MIL-C-50652/1A (AR)
AMENDMENT 1
28 December 1992

MILITARY SPECIFICATION

CIRCUIT CARD ASSEMBLY: 10548018
(GENERATOR, MODULATOR TRIGGER)

Figure 1: Delete "Mod. Trigger Generator 10548018" and substitute "Mod. Trigger Generator 9355881".

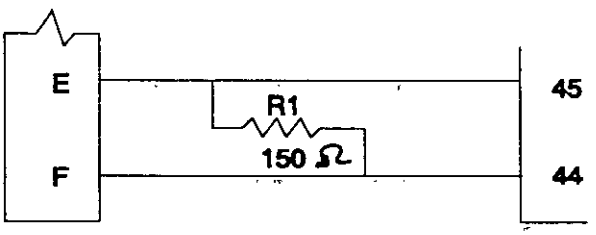
Add "R1" as shown:
